<p>Safety Recall: NHTSA # 23V-102 March 2023</p>

IMPORTANT SAFETY RECALL

NHTSA # 23V-102

Certification Label

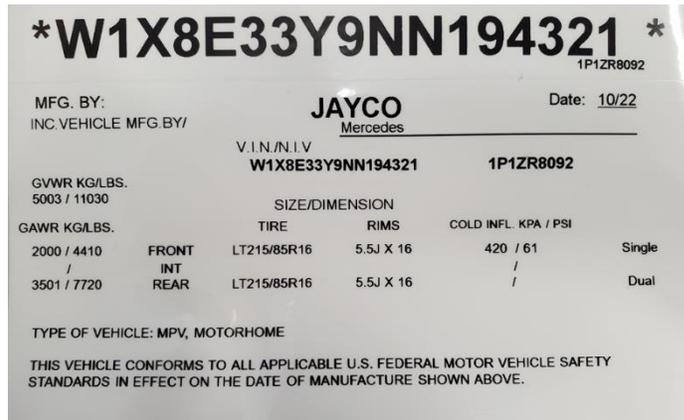
- Reason for this recall*** The certification label may be missing the rear axle information including the Gross Axle Weight Rating (GAWR). Missing axle information may result in the vehicle being overloaded, increasing the risk of a crash.
- Recall Remedy*** Remove the incorrect certification label and attach the new correct certification label. The Recall Remedy is free of charge. The remedy will take approximately 15 minutes to complete.
- What we need you to do*** You can install the correct label on your Recreational Vehicle or you can contact an authorized Jayco Inc. dealer and schedule an appointment to have the label installed. The correct label and instructions are enclosed.

The certification label below is only an example of the label you are to replace.

1. **Class A** models locate the label on the inside of the RV at the interior wall next to the driver's seat. **Class B** and **Class C** models locate the label on the inside of the driver's door.
2. Remove the existing label. Using isopropyl alcohol and a shop rag, remove any adhesive residue from the surface where the original label was removed.
 - a. Allow the area to dry for at least 30 seconds.

1. Remove the protective back from the new label. Align the new label in the same location of the original label and apply it to the surface. Remove any air bubbles from the label.
 - a. Note: Do not attempt to remove or adjust the label once it has touched the surface. Doing so may damage the label or cause it not to adhere properly to the surface.
